RE: Revised Application Deficiency Report #4 - Certificate of Public Convenience and Necessity for the Riverside Transmission Reliability Project – Application No. A.15-04-013

DEFICIENCY REPORT #4 (REVISED) FOR THE RIVERSIDE TRANSMISSION RELIABILITY PROJECT APPLICATION (A. 15-04-013)

Table 1: SCE Riverside Transmission Reliability Project Application 15-04-013 Deficiency Report #4 (Revised 09/22/2016)

- ROW
- Lattice Structure
- Tube Structure
- Proposed Transmission Line
- Indicative Access Road
- GDAD Buffer Area
- Cultural Survey Area

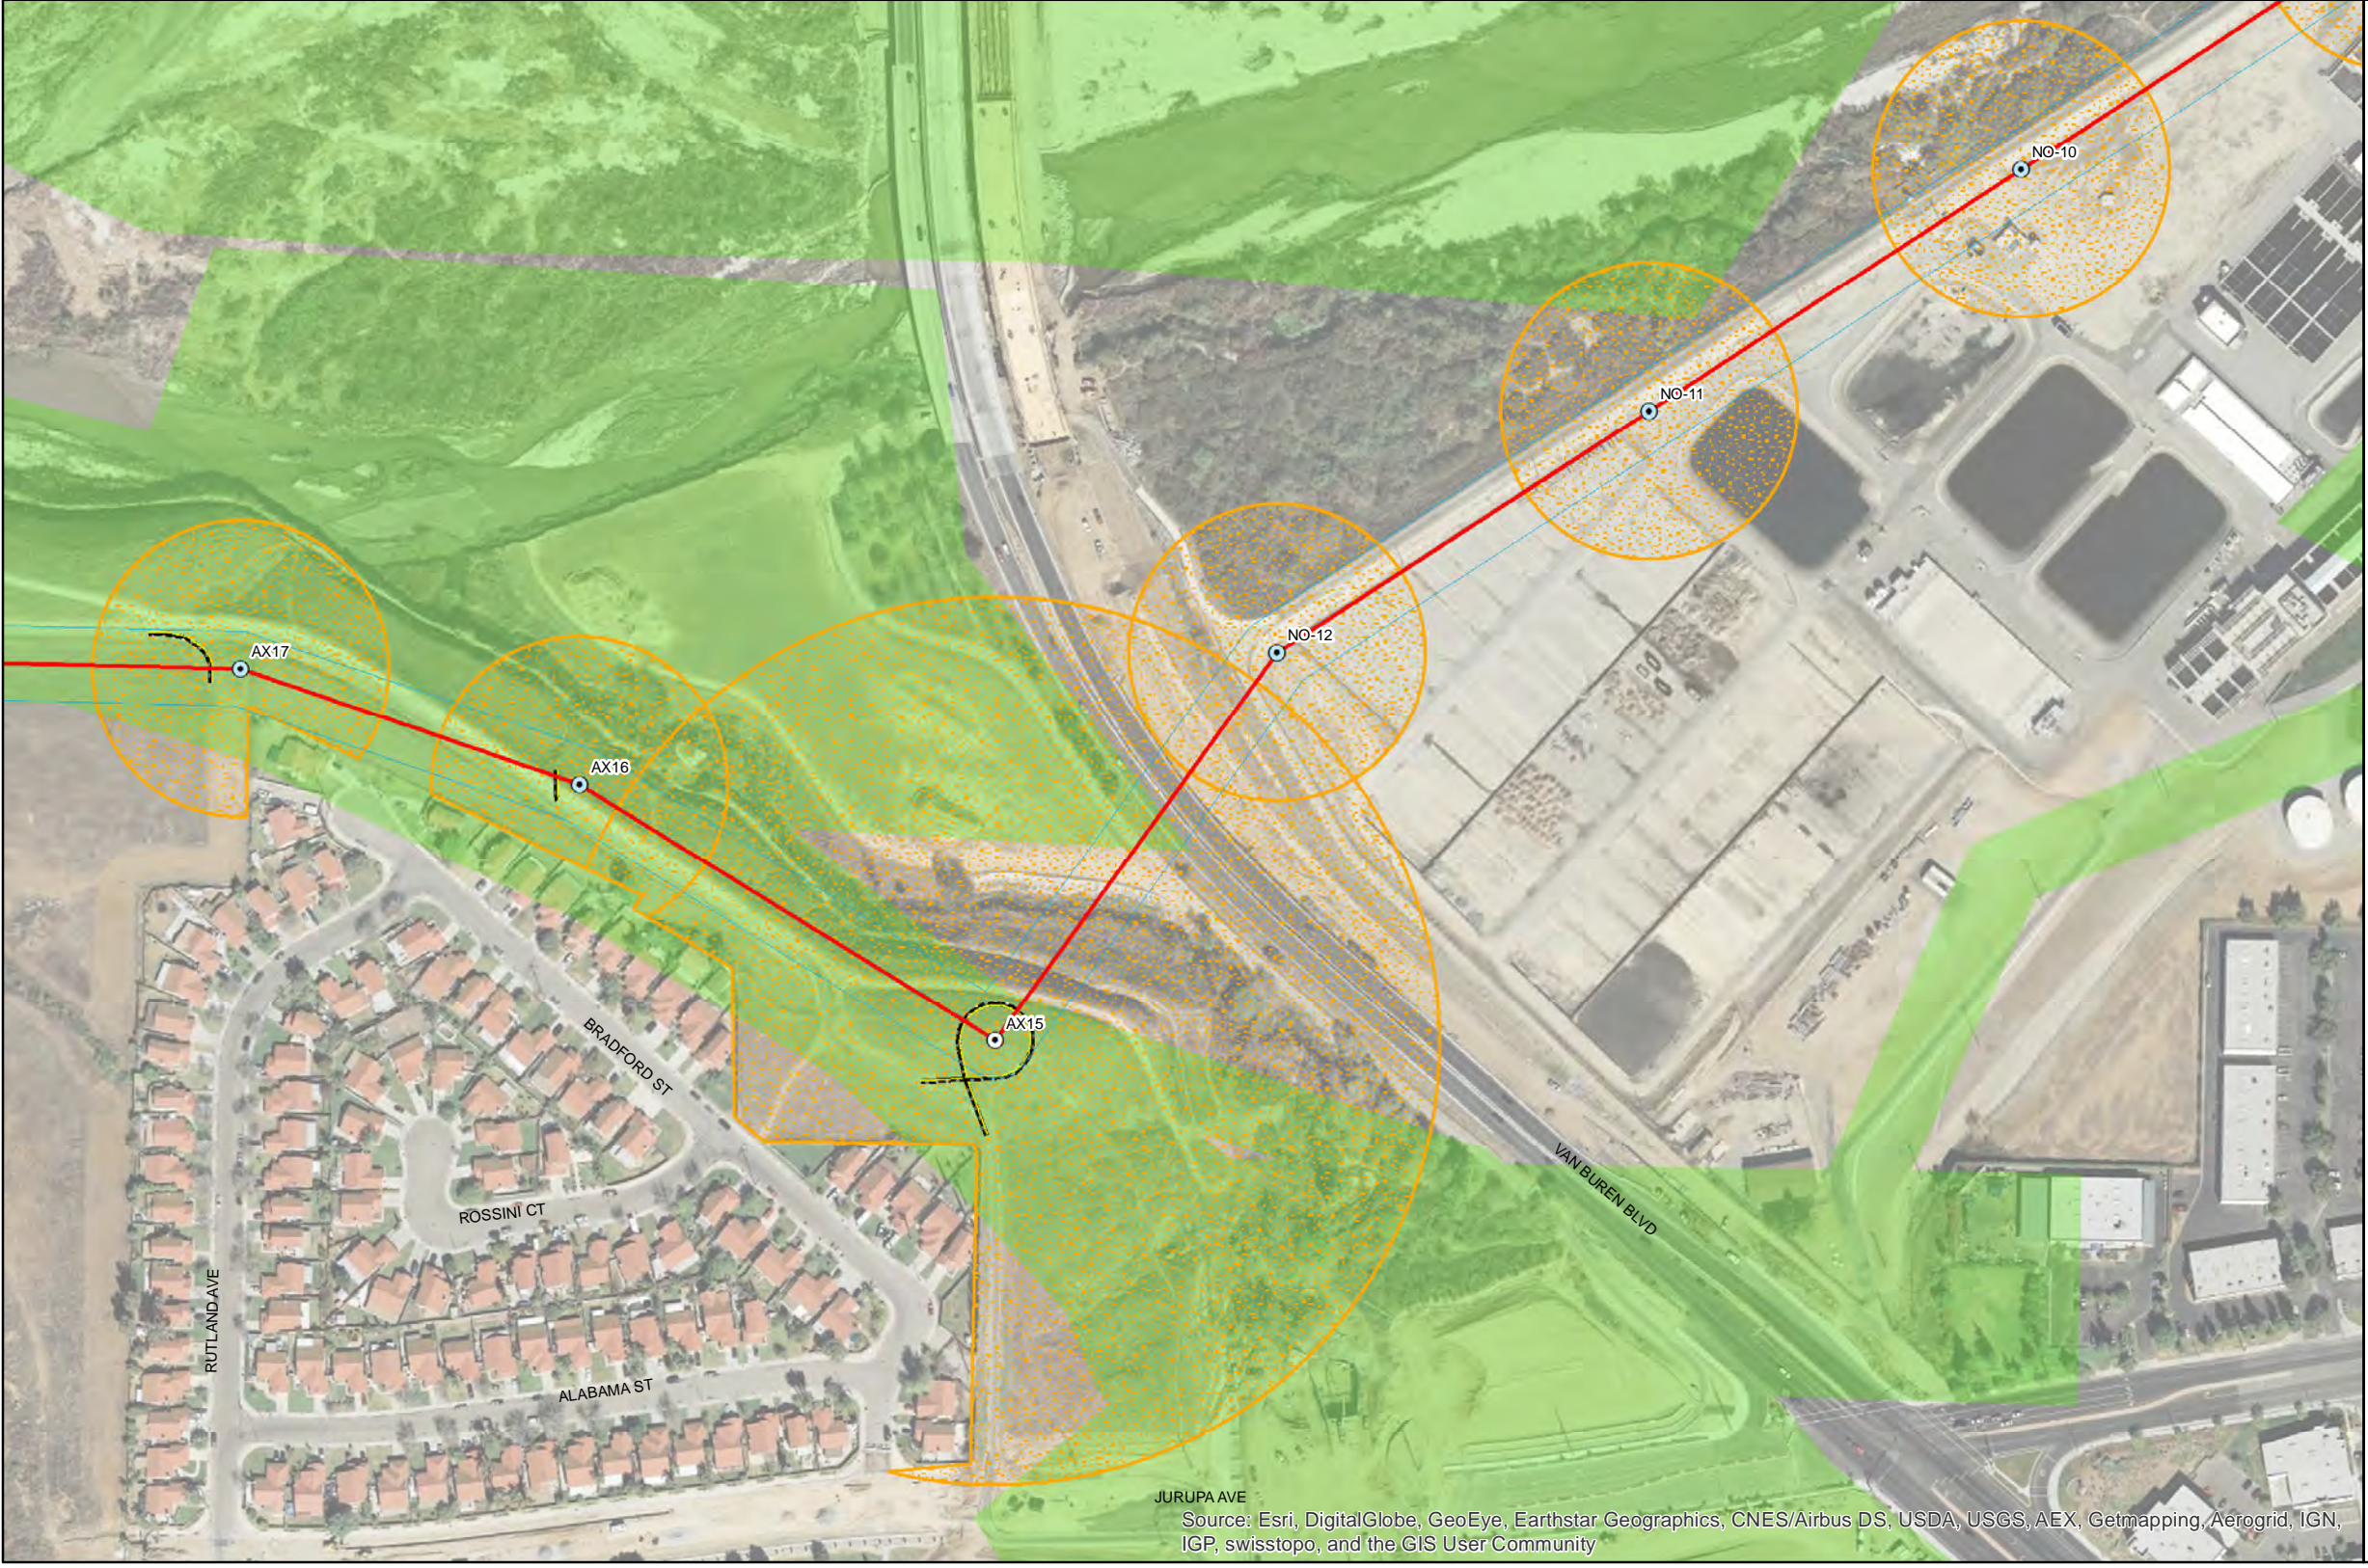
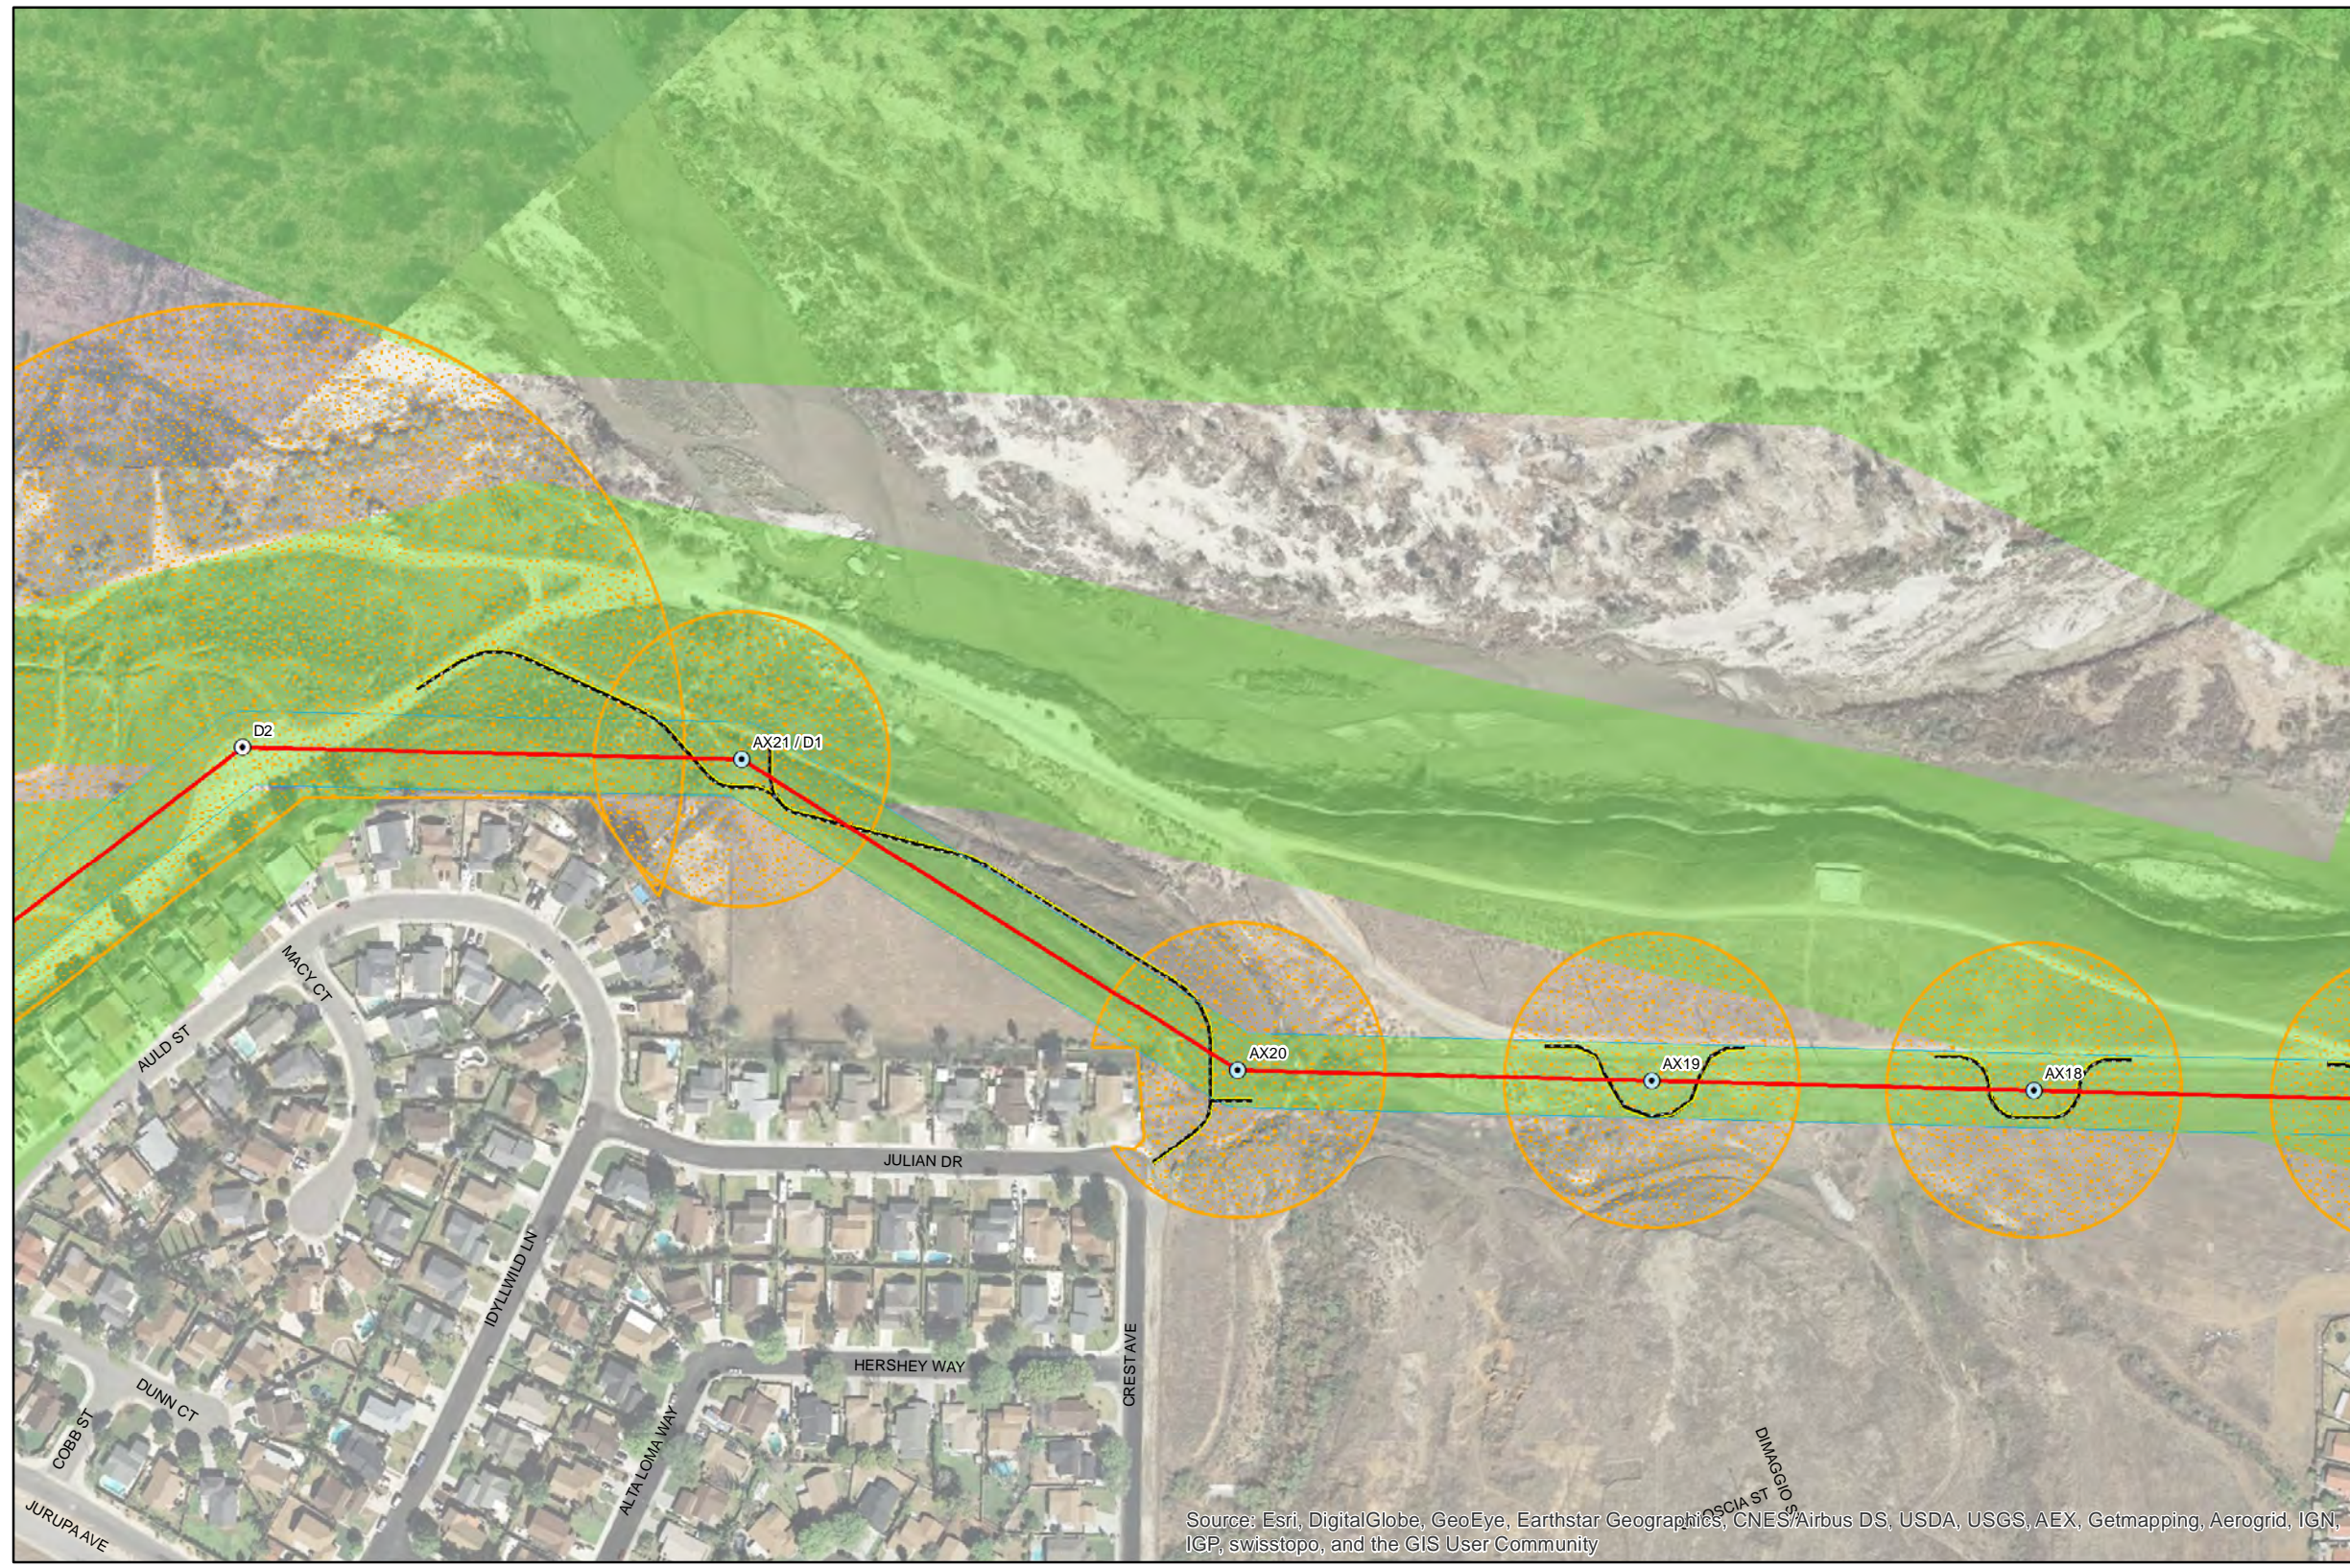
6	Yes	<p>Provide cultural resource survey reports and data for all unsurveyed portions of project disturbance areas as refined in response to Items 1 through 3</p>

Number	Information Requested Previously?	Deficiency
		<p>above (see also Attachment B) and the revised alignment northwest of the Santa Ana River.</p> <p>The cultural resource survey reports need to contain the results of a record search performed through the California Historical Resources Information System (CHRIS) – Eastern Information Center as well as the results of pedestrian surveys for all unsurveyed work areas along the overhead alignment including those areas shown on Attachment B, the agricultural area north of Limonite Avenue, and the underground alignment within the Goose Creek Golf Club. Please also provide the results of a cultural resources records search performed through the CHRIS for the proposed underground alignment within 68th Street and Pats Ranch Road. Provide all supporting details in the cultural resources survey report (i.e., site records and maps).</p>
7	Yes	<p>Clarify how SCE expects to obtain a permit for new poles located in the Hidden Valley Land and Water Conservation Fund (LWCF) area. How will NEPA be handled for new poles in this area? Where and how will SCE replace the impacted LWCF area?</p> <p>The Land Use section in the 2013 RTRP Final EIR lacks analysis of the land use impacts resulting from conversion of LWCF areas. Mitigation Measure REC-02 in the recreation section does not define where or how SCE would replace the LWCF area or obtain the necessary permits from the National Park Service. Further information is needed to verify the feasibility of the proposed “land conversion” for the proposed transmission line structures within the LWCF area.</p>
